July 30, 2007

**Re: Floodplain GE-Pittsfield/Housatonic River Site
Floodplain Residential and Non-Residential Properties Adjacent to 1½ Mile Reach of
Housatonic River (GECD710 and GECD720)
Addendum to Supplemental Information Package for Selected Phase 2 Floodplain Properties**

Revised Tree/Shrub Inventory
and Restoration Plan

FIGURE
E-2

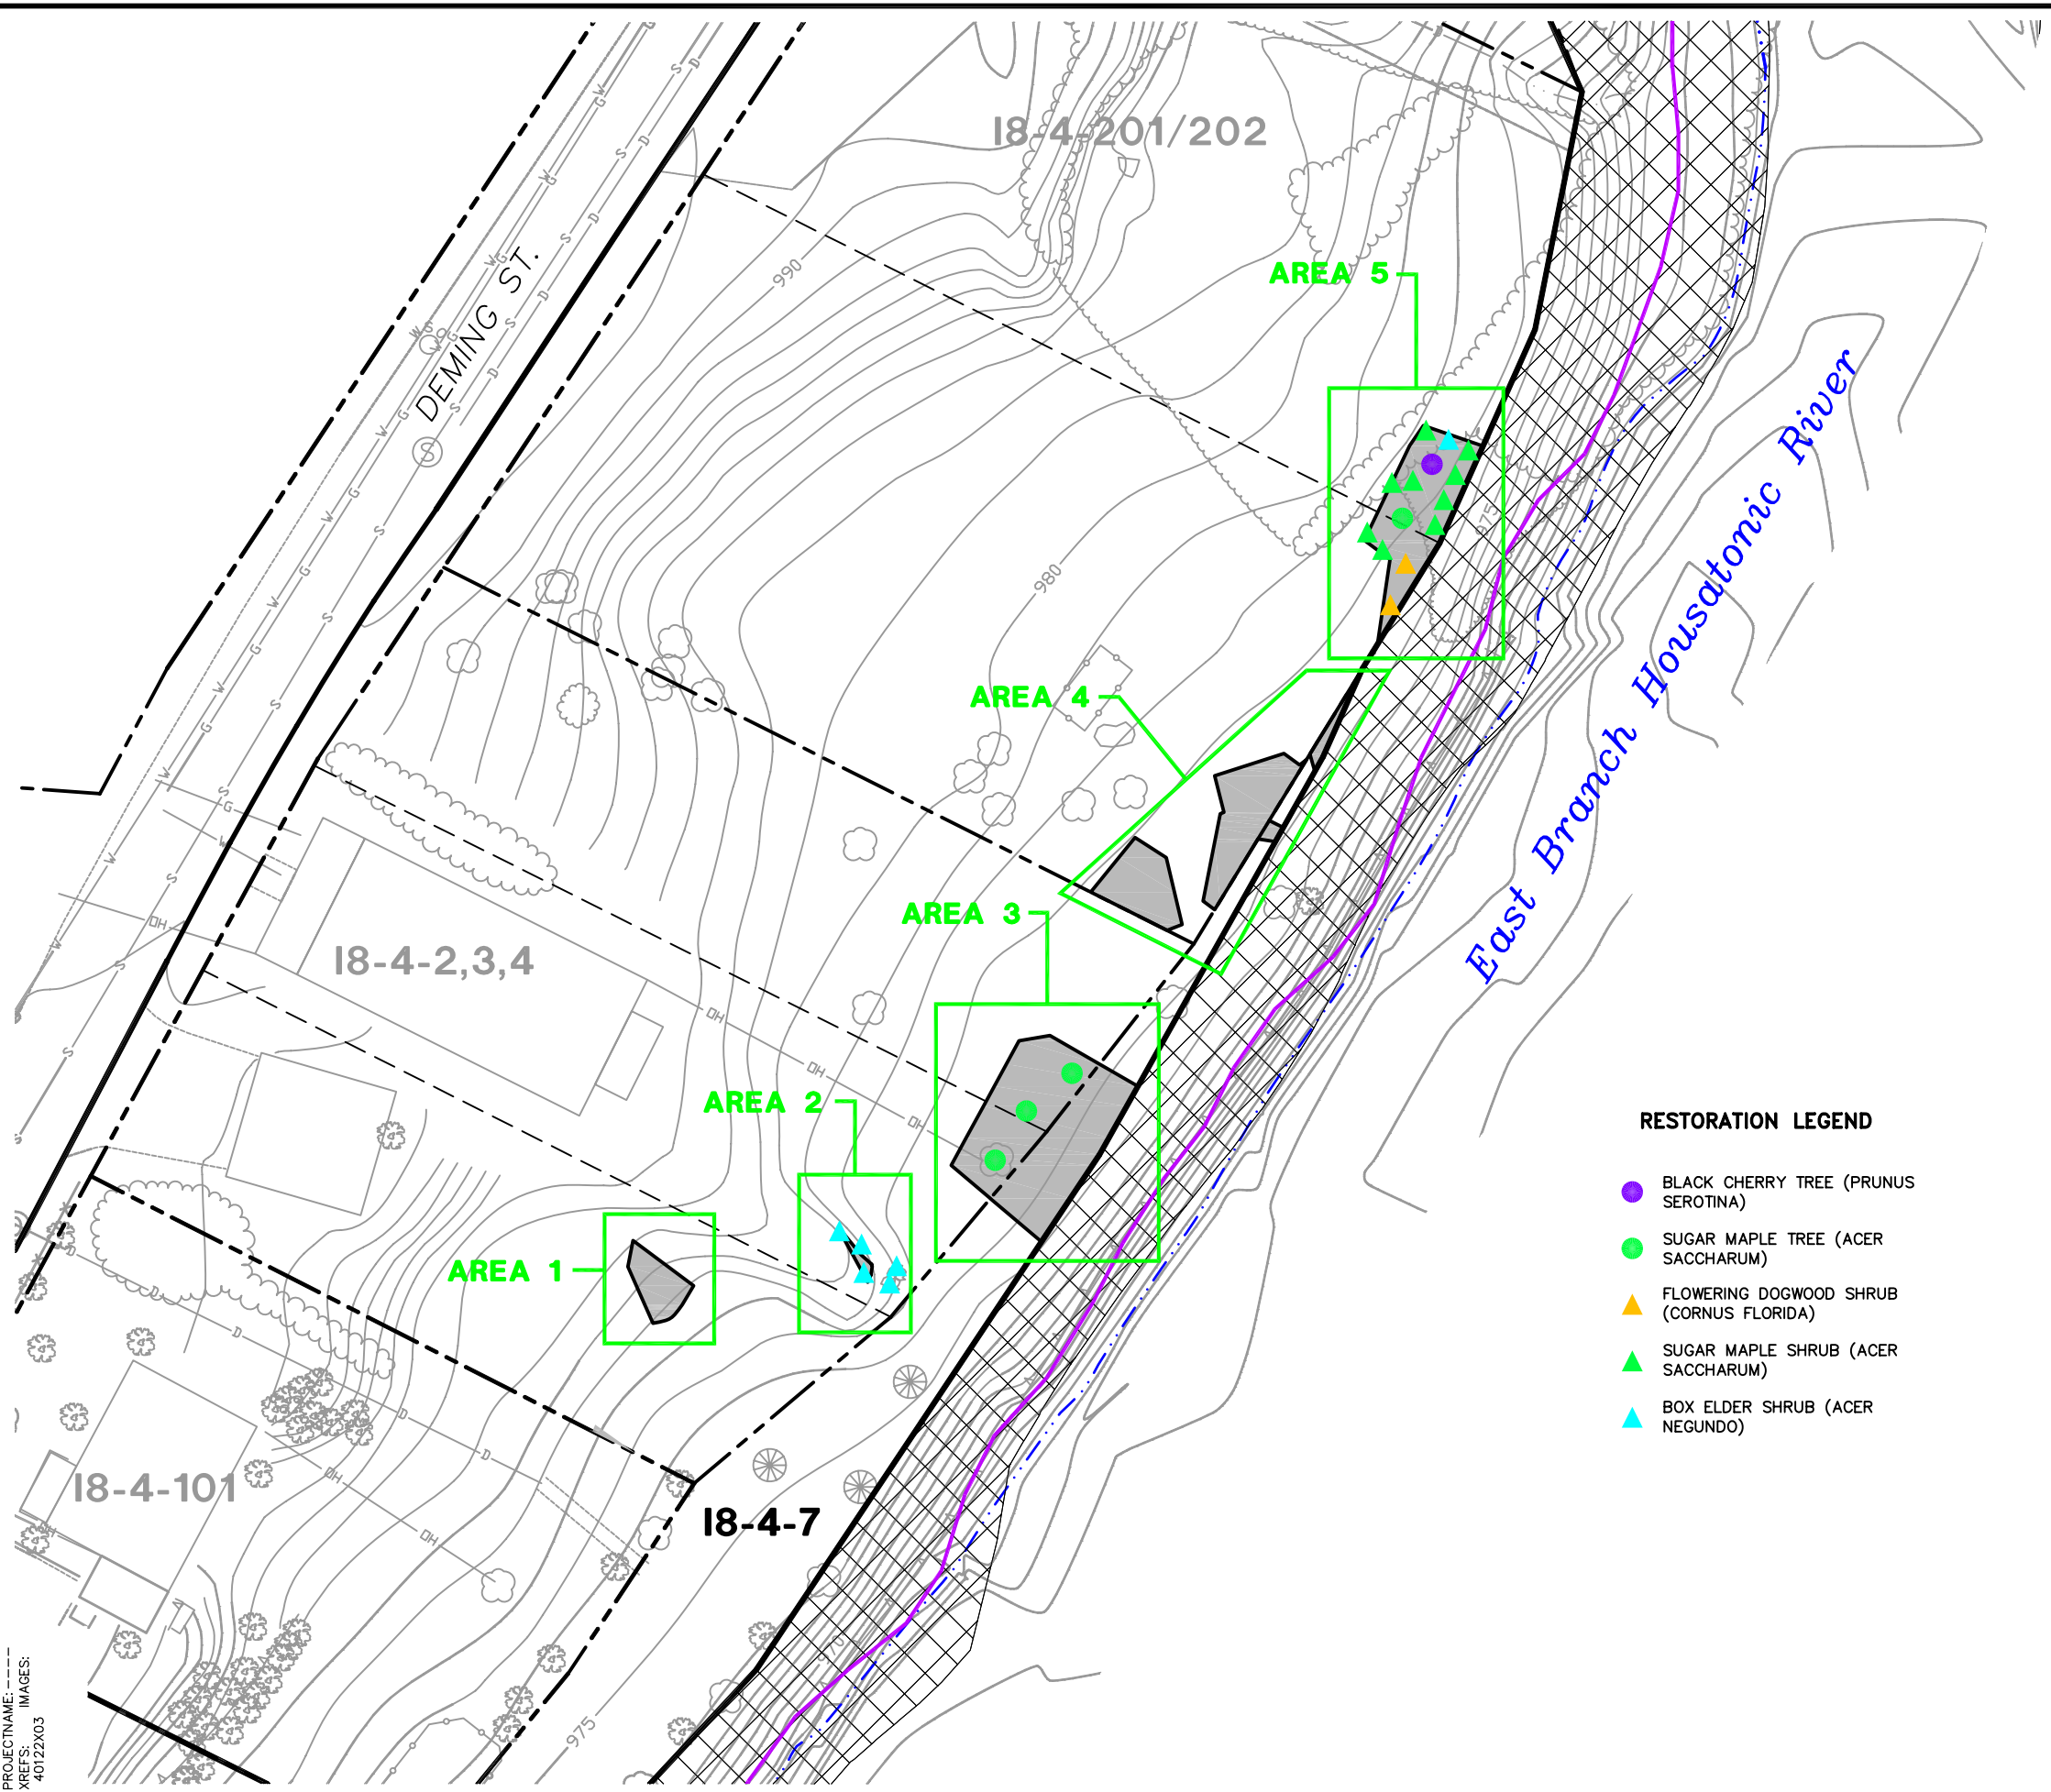
In accordance with Condition No. 2 of EPA's letter, GE has revised the Tree/Shrub Inventory and Restoration Plan previously included as Attachment E to the SIP. Specifically, Table E-2 of this plan has been modified to require that all proposed small trees/shrubs (box elders, sugar maples and any substitutions) be a minimum of four feet in height. In addition, GE has eliminated the proposed planting of the Staghorn Sumac (*Rhus typhina*) in Planting Area 5. The revised Tree/Shrub Inventory and Restoration Plan for the Phase 2 floodplain properties is provided in Attachment A.

1. Small trees/shrubs (i.e., box elders, sugar maples, and any substitutions) shall be a minimum of four feet in height.
2. Refer to Figure E-2 for tree/shrub planting areas.
3. Tree/shrub restoration activities shall be performed in accordance with Materials and Performance Section 02210 - Floodplain Tree and Shrub Planting.
4. -- - Not applicable.
